TISDALE WEIR REHABILITATION AND FISH PASSAGE PROJECT

Final Environmental Impact Report

Prepared for
California Department of Water Resources

August 2021

Figure 17
TUFLOW Model – Change in Average Depth by Parcel (Wet Days)
Tisdale and Sutter Bypass (Critical WYs), Project Conditions

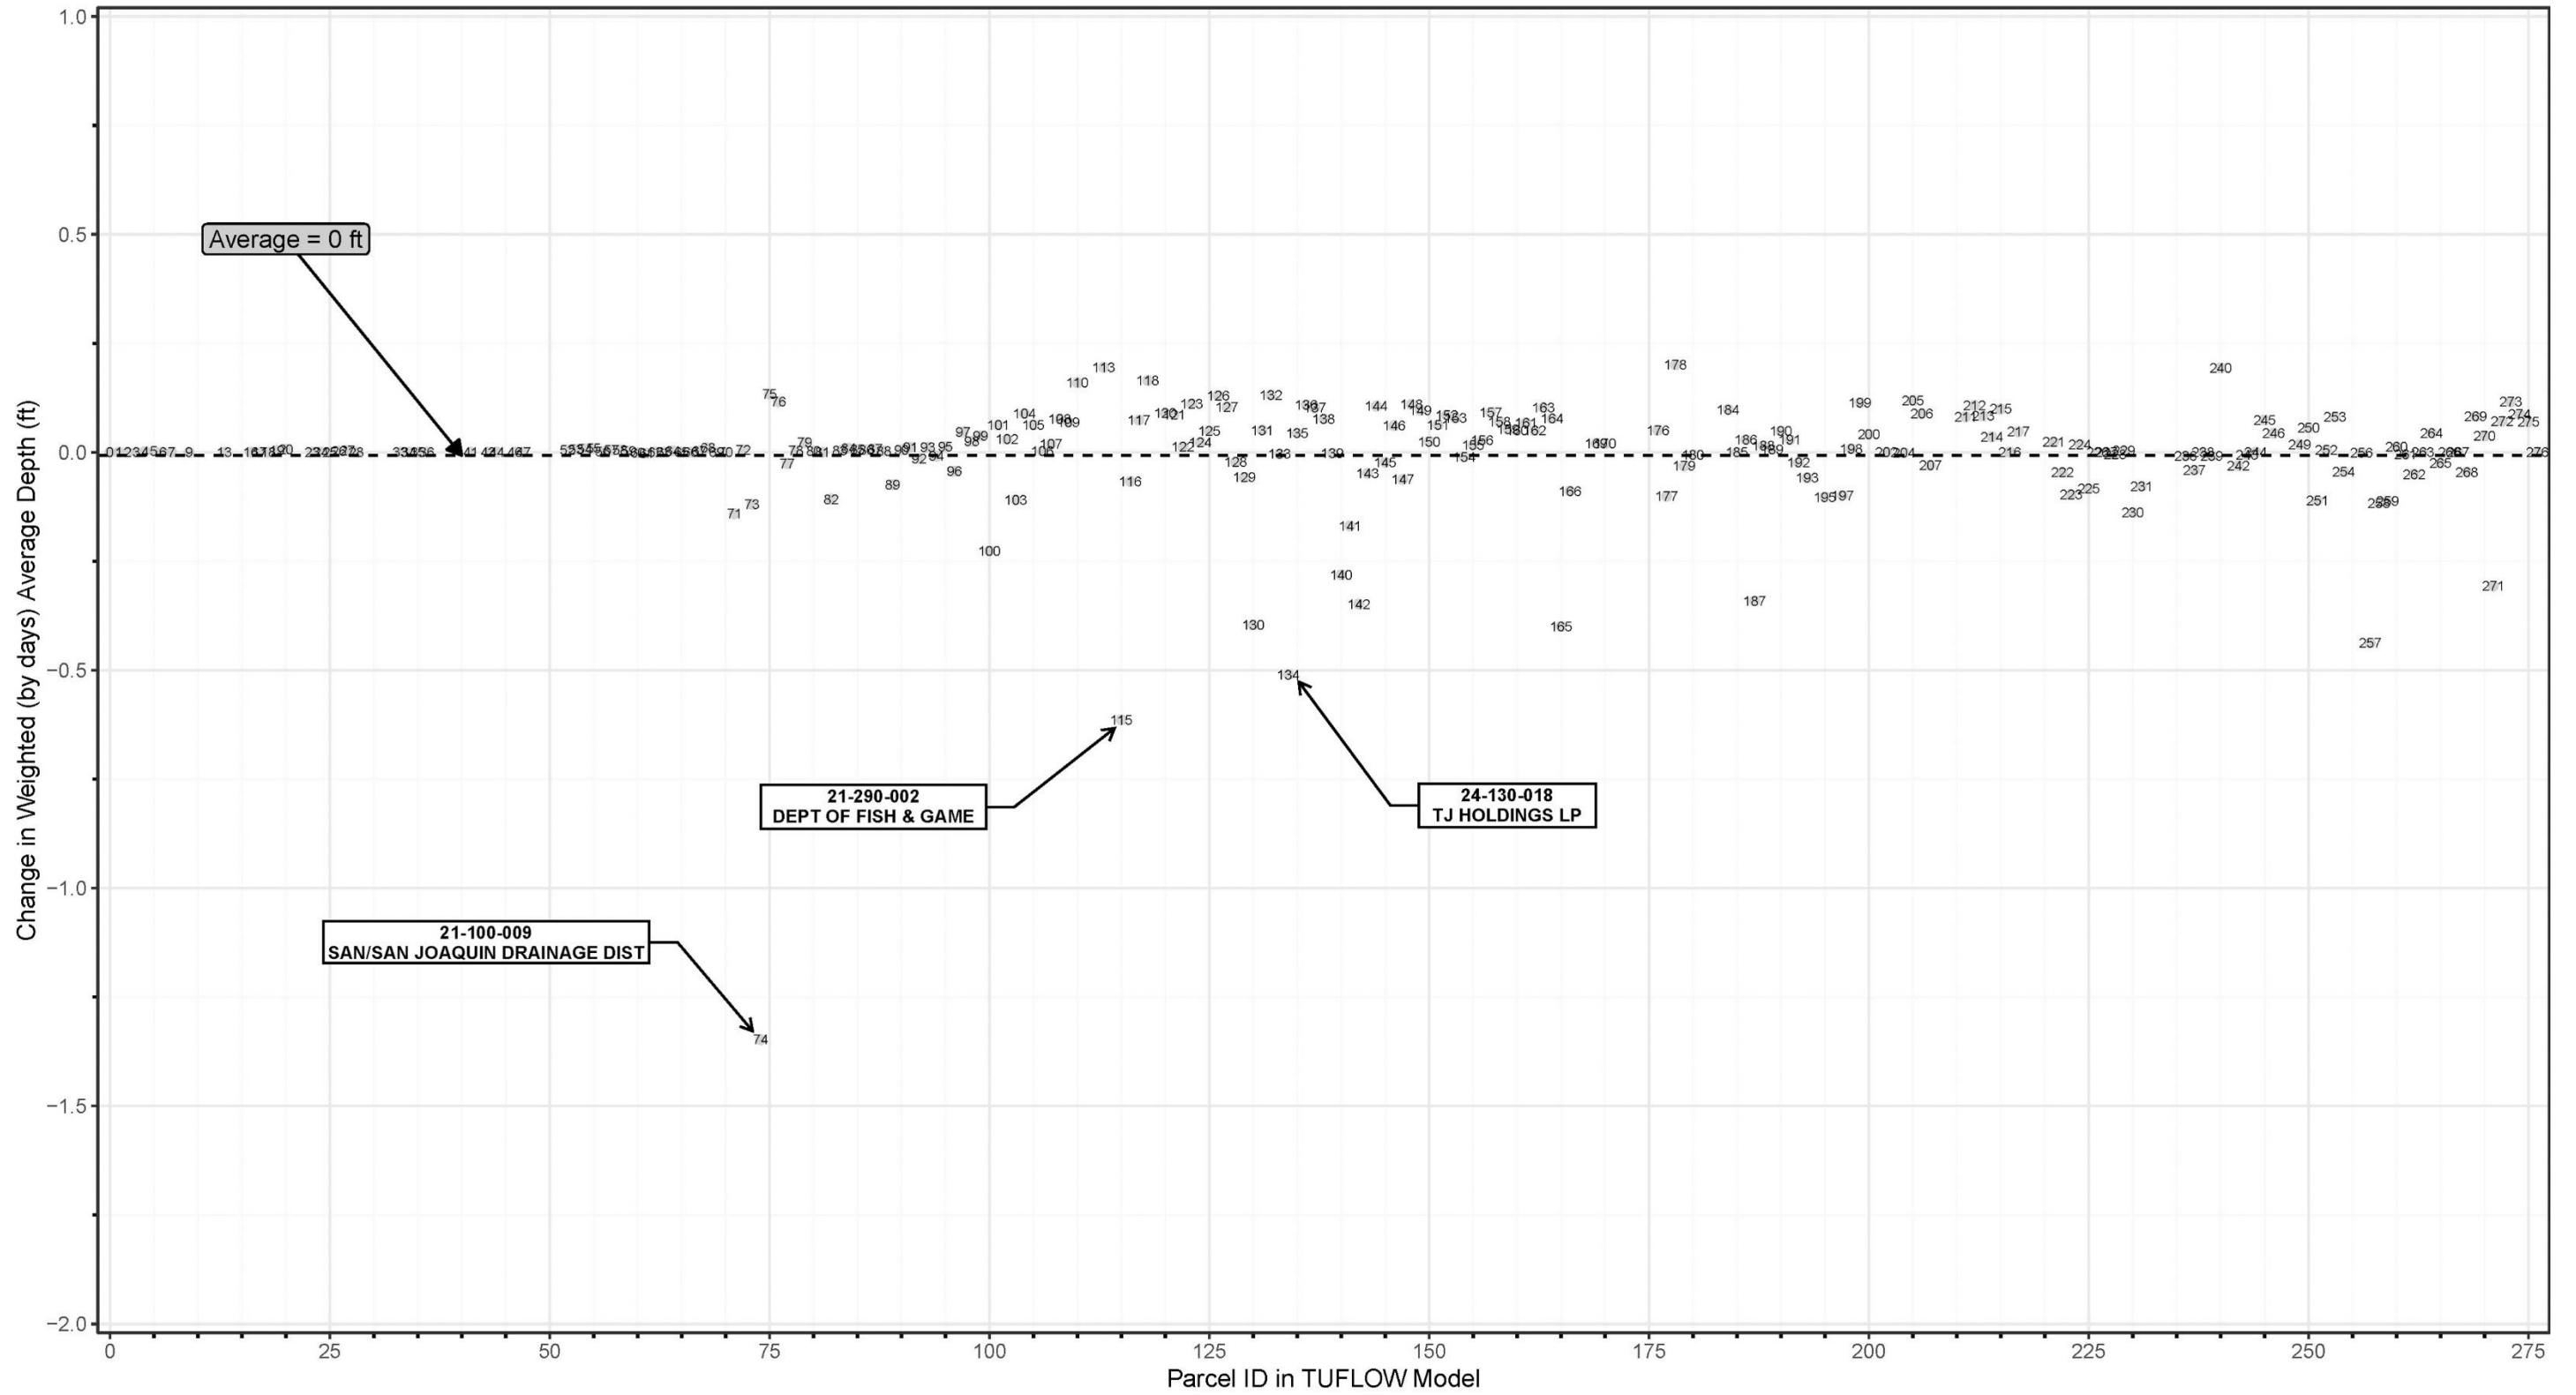
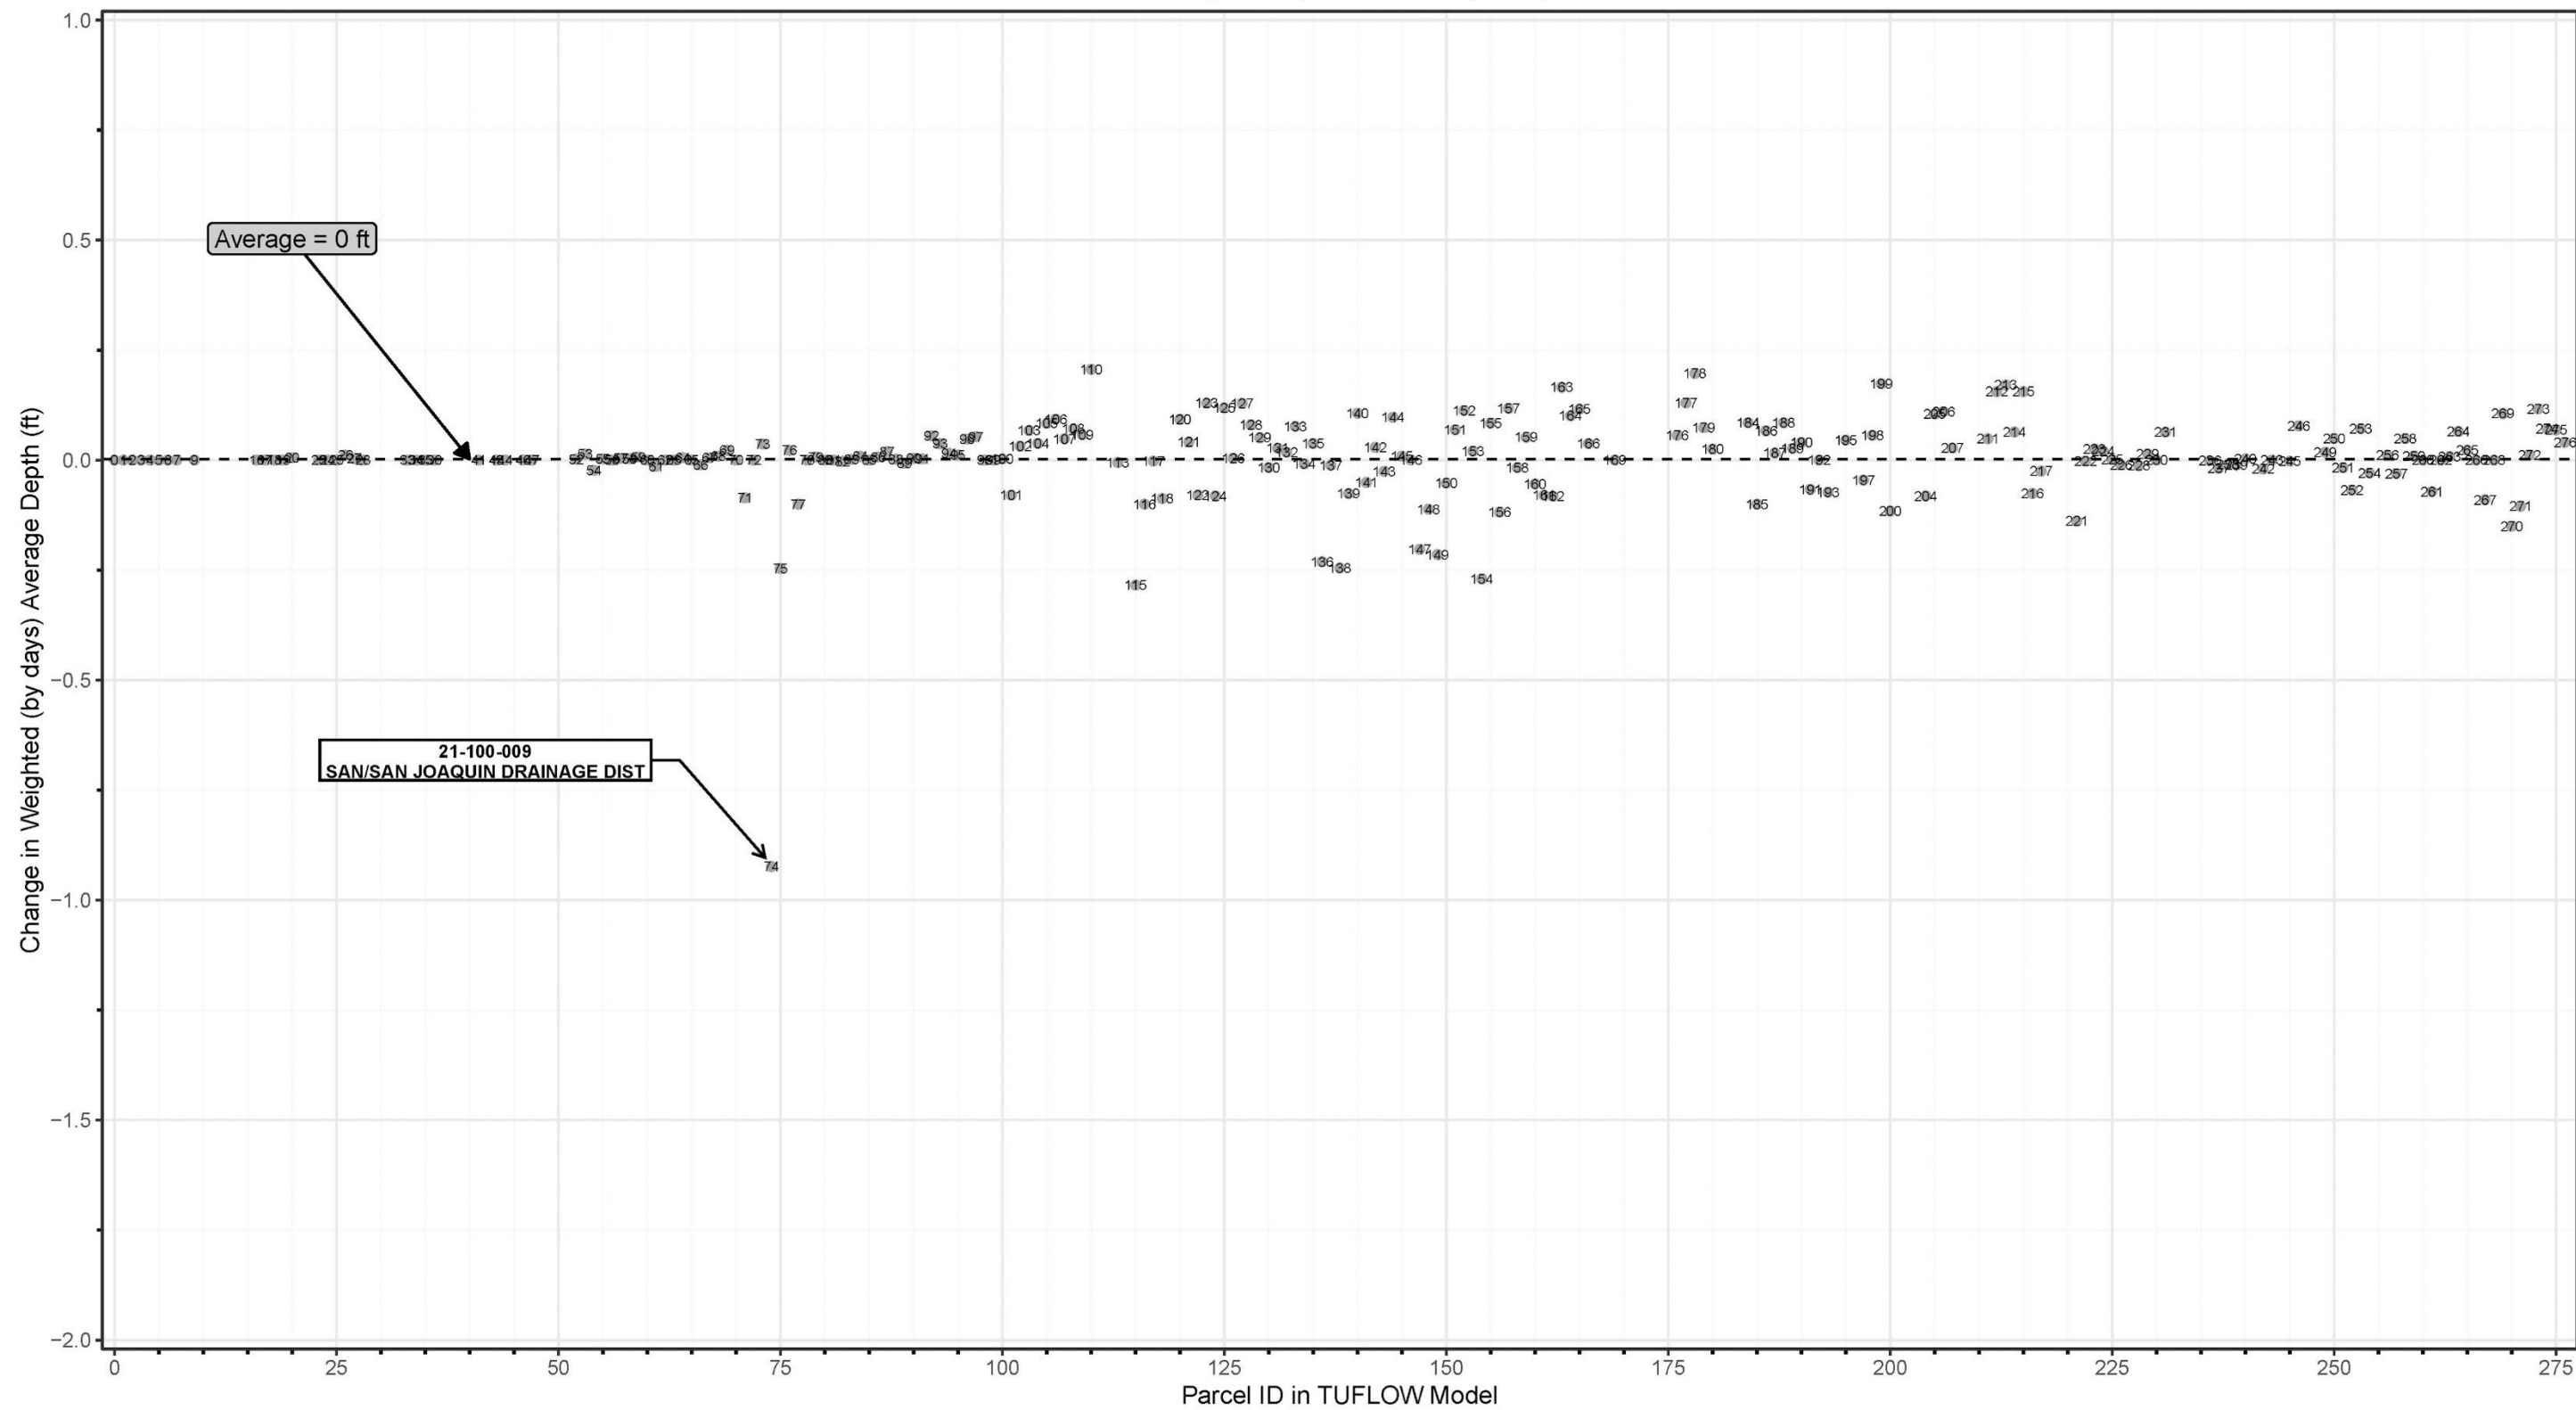
Figures 13 through 24 in Attachment E of this FEIR present the average changes in water depth, by water year type, for each parcel in the Sutter Bypass and, as shown, the predicted changes in water depth are very minor. As evident in Figures 13 through 24, the predicted increases in depth for wet days and dry days that are greater than approximately 0.5 feet are for parcels that belong to the Sacramento/San Joaquin Drainage District or the California Department of Fish and Wildlife (CDFW). In addition, Attachment F of this FEIR provides the change in the number of wet days for the waterfowl season for all water years and parcels in the Sutter Bypass.
